Informal document GRPE-86-45
86th GRPE, 30 May – 02 June 2022
Agenda item 3(c)

This Informal Document proposes amendments to document ECE-TRANS-WP29-2020-120e to incorporate changes adopted in Europe as part of the Euro 6e step amendments. All proposed changes are shown as tracked changes.

Proposal for a new UN Regulation No. [XXX] on uniform provisions concerning the approval of light duty passenger and commercial vehicles with regards to real driving emissions (RDE)

Figure A5/1

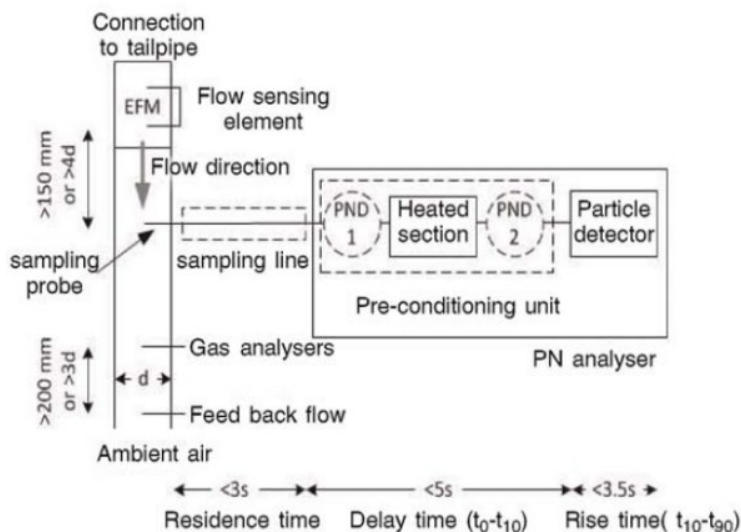
The PN analyser shall consist of a pre-conditioning unit and a particle detector that counts with 50 per cent efficiency from approximately 23 nm. It is permissible that the particle detector also pre-conditions the aerosol. The sensitivity of the analysers to shocks, vibration, aging, variability in temperature and air pressure as well as electromagnetic interferences and other impacts related to vehicle and analyser operation shall be limited as far as possible and shall be clearly stated by the equipment manufacturer in its support material. The PN analyser shall only be used within its manufacturer's declared parameters of operation. [An example of a PN analyser setup is provided in Figure A5/1.](#)
